FINAL ENVIRONMENTAL IMPACT REPORT

18-UNIT APARTMENT BUILDING

4050 - 17th STREET

EE73.231

VICINITY MAP WITH ZONING

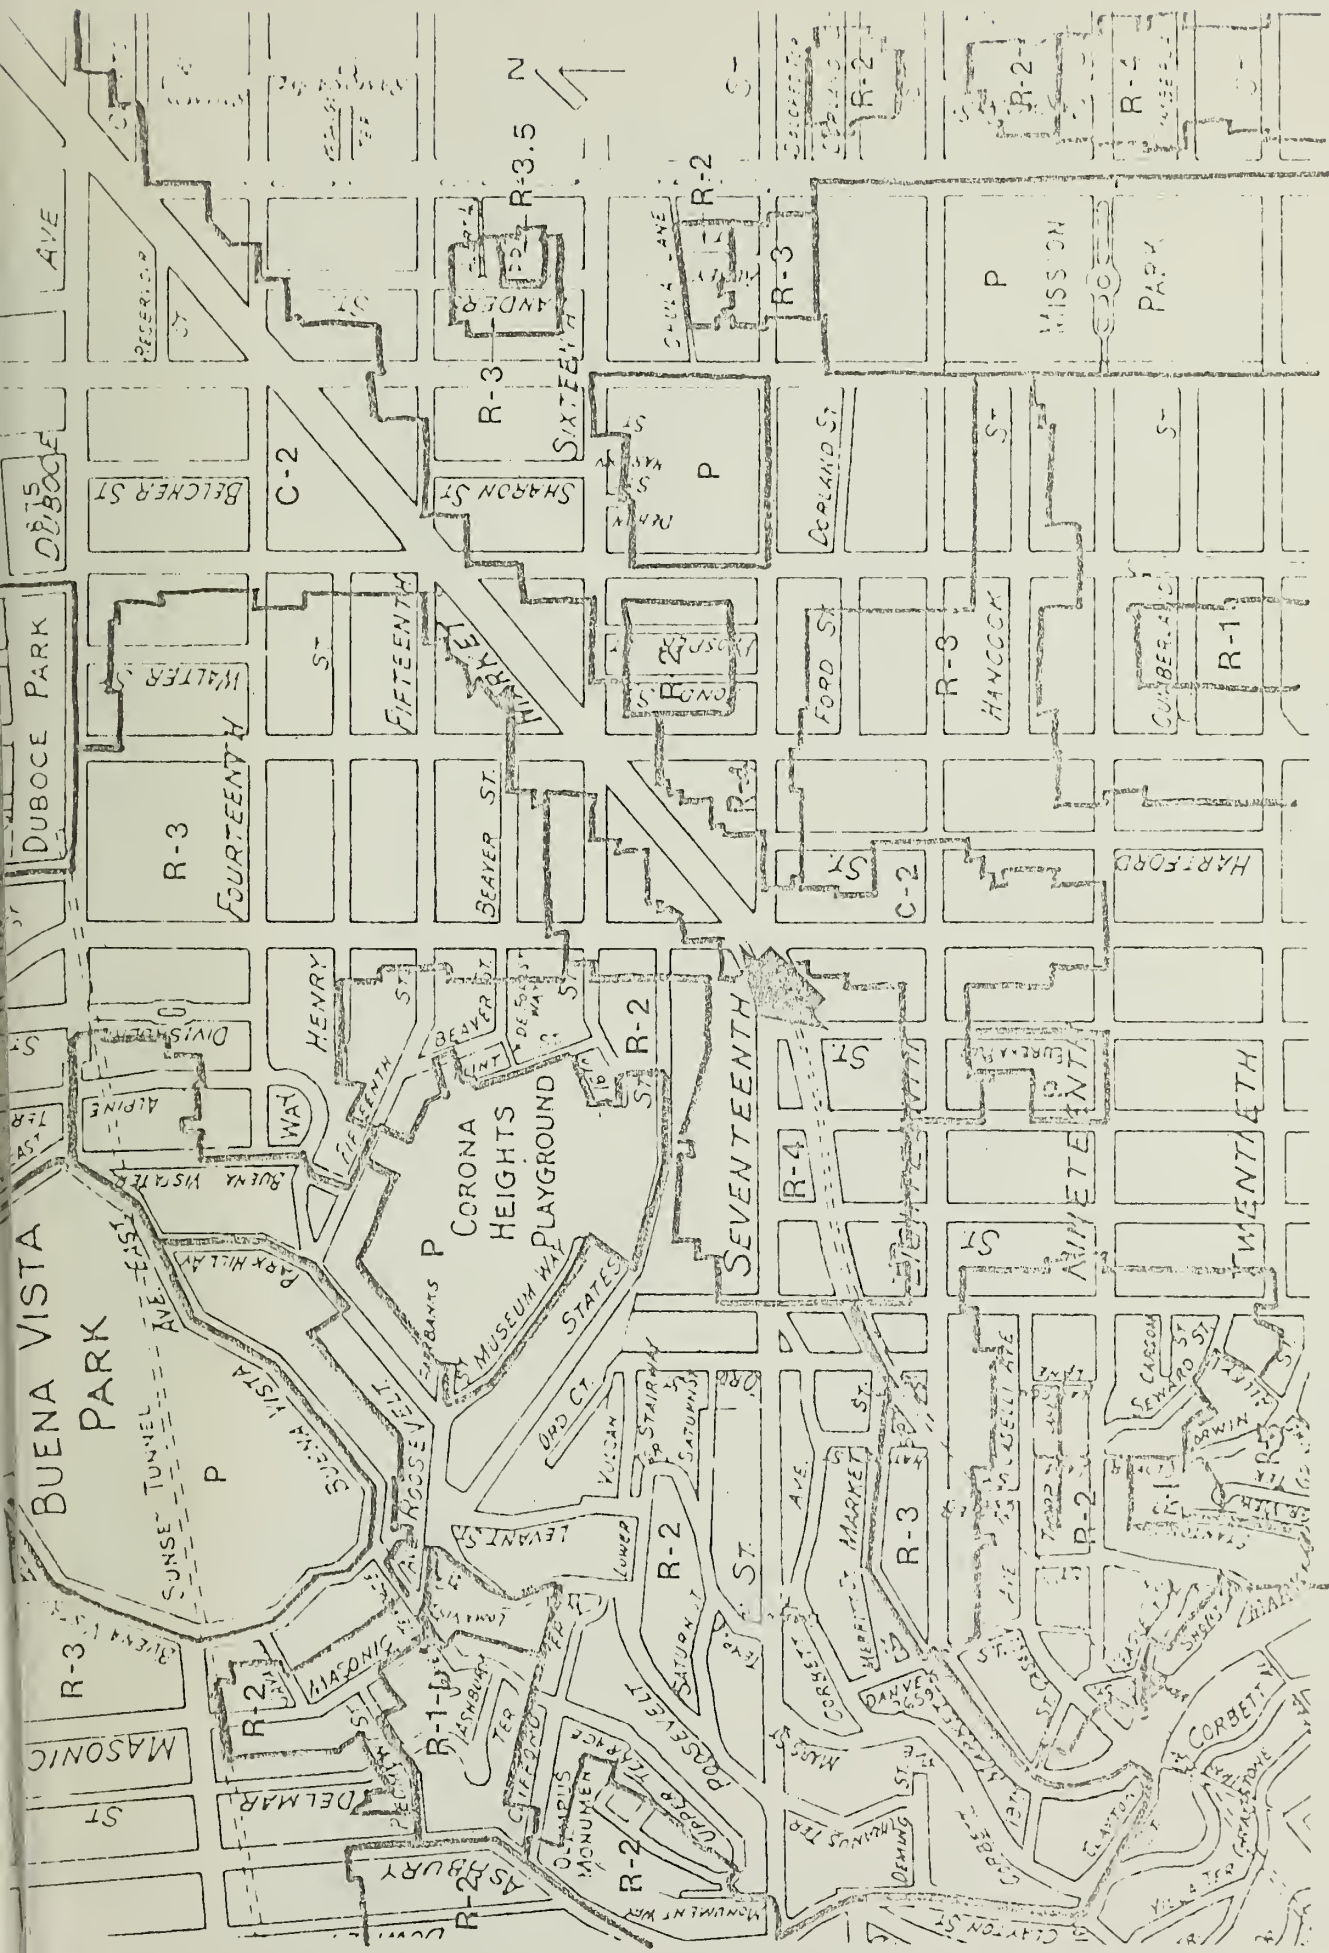
- COMMENT 8: The correspondence reproduced on page 50 is illegible and other correspondence should have been included. The zoning in the area has changed, making the published zoning map incorrect.

- RESPONSE: These items have been corrected in the final version.
- COMMENT 9: Table I on page 5 is misleading as to lot coverage because we feel that paved parking is lot coverage.

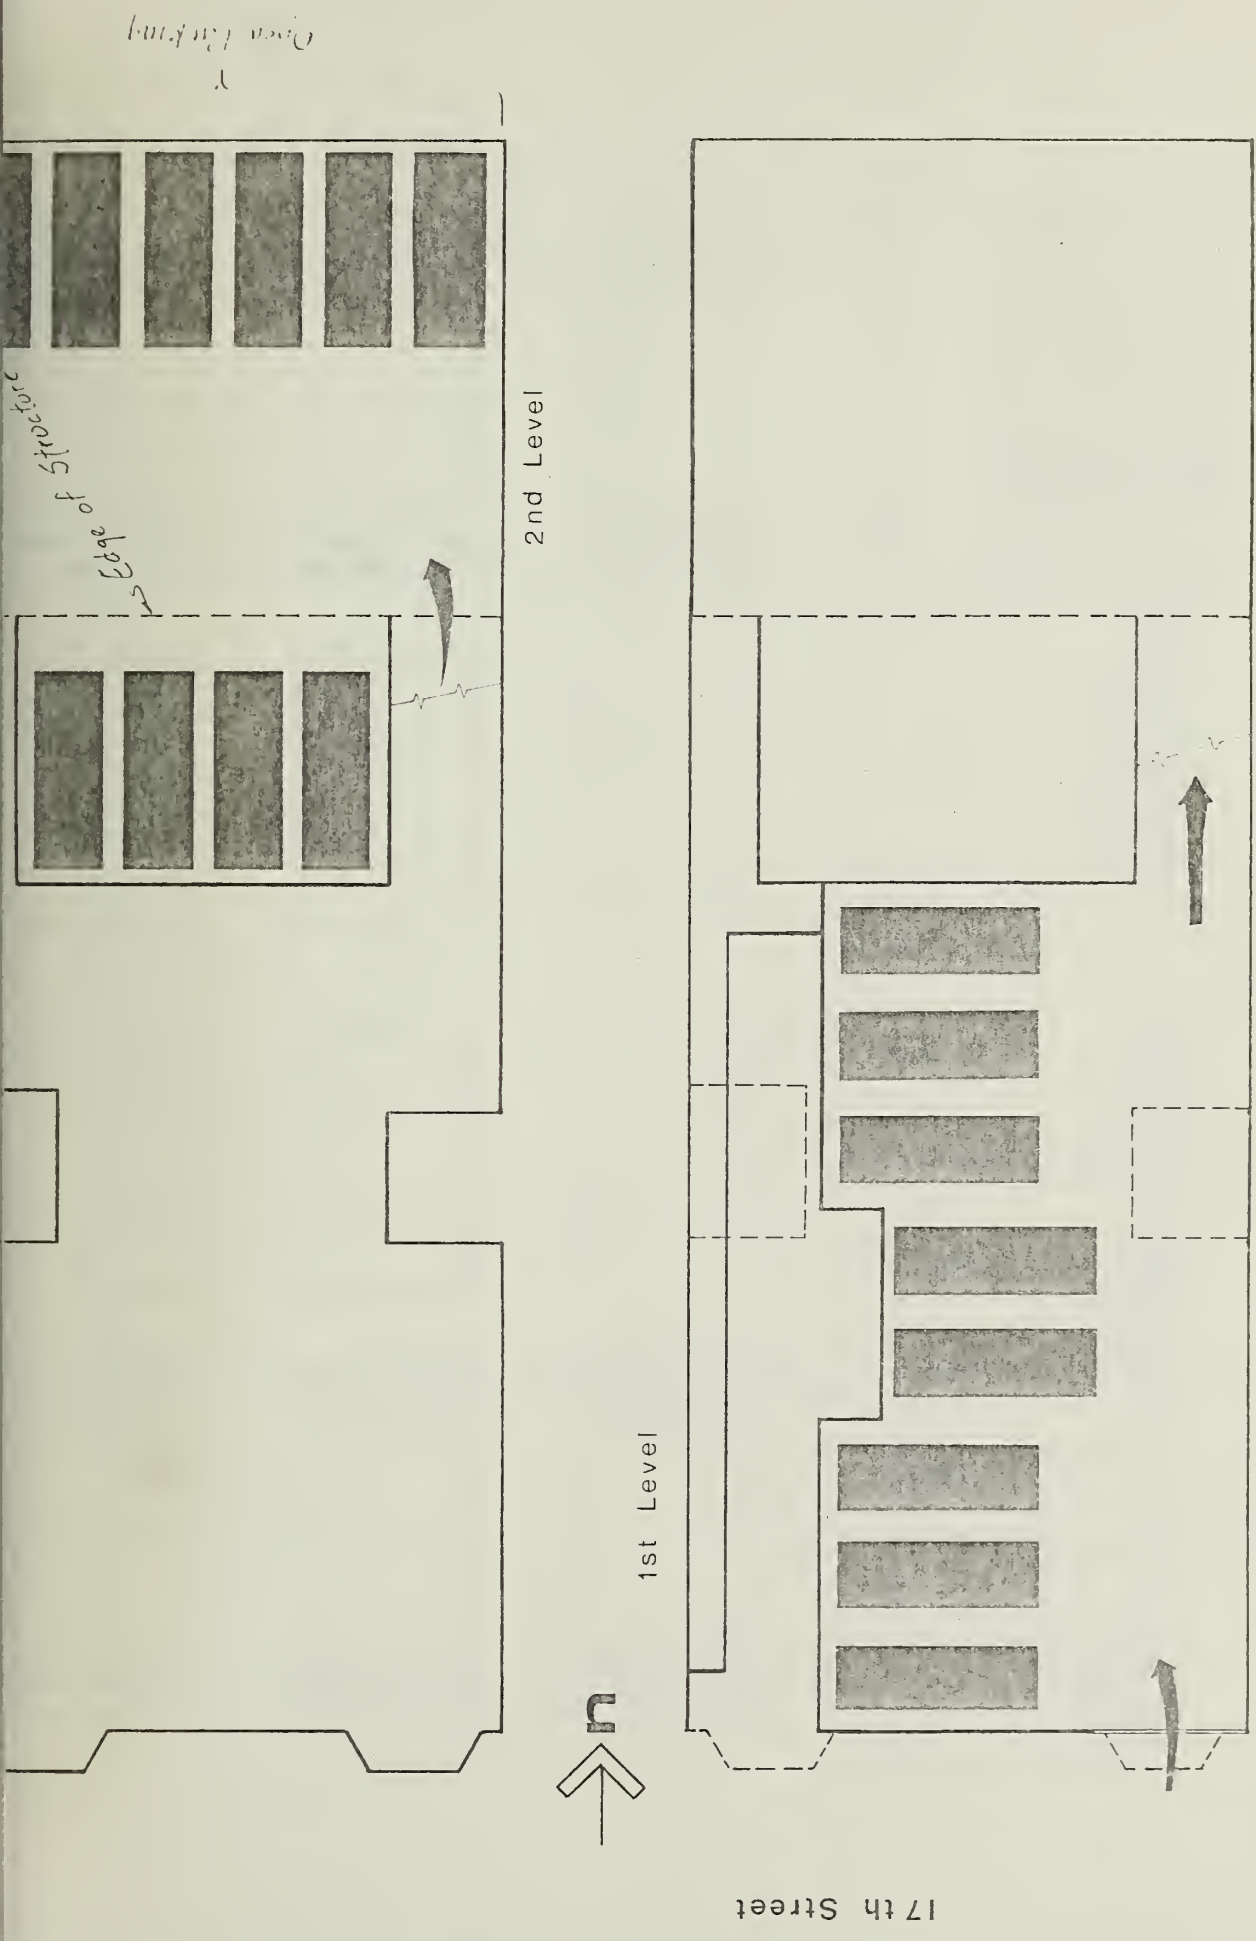
MENT 12: We want assurance that the garage doors and other amenities shown on page 6 will actually be provided. Also, Plate 6 does not show fire escapes. We understand that the fire escapes for this building will be visible from the street.

PNSE: The building plans advertised as being available in the Department of City Planning during the review period for this EIR show the location of the fire escapes, and also show that the garage door will be provided.
